# Program Bulletin

## CUSTOMER SATISFACTION PROGRAM

**SUBJECT:** Engine Harness Chafing On EGR Stud

**MODELS:** 2015 Chevrolet Silverado HD  
2015 GMC Sierra HD  
Equipped with the Duramax Diesel 6.6L Engine (RPO LML)

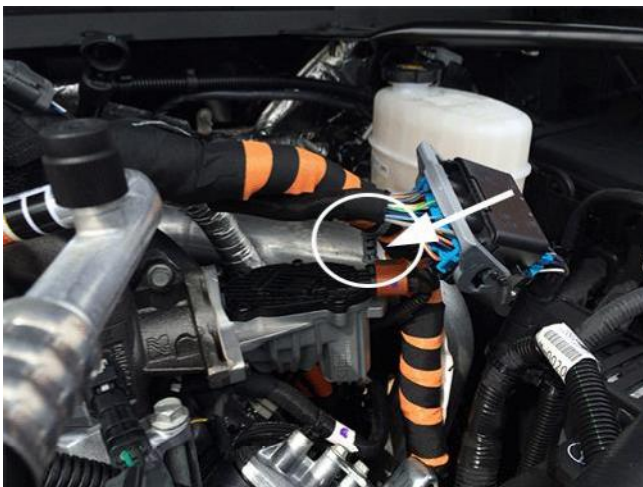
**Certain** 2015 model year Chevrolet Silverado HD and GMC Sierra HD model vehicles equipped with the Duramax Diesel 6.6L Engine (RPO LML) may exhibit engine harness chafing on the EGR stud.

1. Open hood and install fender covers.
2. Inspect the main engine harness for any damage. If any damage is found, repair wire(s). Refer to *Wiring Repairs* in SI before proceeding to step 2.

3. Disconnect the X107 (36 way) connector and reroute the male end under the main engine harness (orange flex wrap) and reconnect X107 connector.

Dealers are to inspect the harness for damage, reroute the harness, and install a clip onto the EGR stud.

4. Locate and install the gray standoff clip onto the EGR stud.
5. Remove fender covers and close hood.
